CHEVRON CANADA REFINERY

REPLACEMENT OF SULPHUR RECOVERY PLANT

PRELIMINARY PLAN APPROVAL APPLICATION #10529

Re: Dispersion Modelling Evaluation of Sulphur Plant Shutdown

# AMBIENT HOURLY SO<sub>2</sub> CONCENTRATIONS ON CAPITOL HILL FIGL RE 8

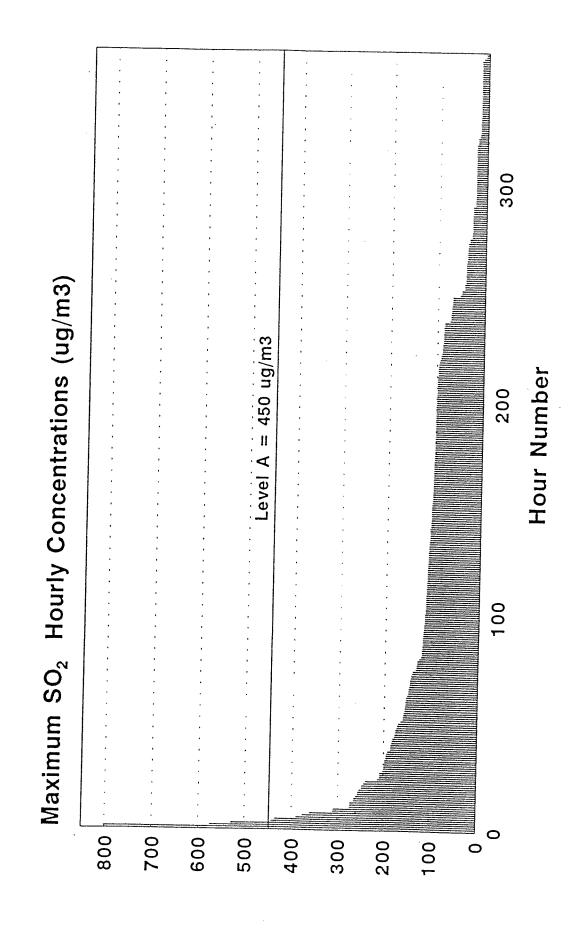
- why was a site 100 m north selected rather than the point of maximum concentration? This graph should indicate levels at the point of maximum predicted impact. Additional graphics of other representative residential areas would be useful to then compare to this site.
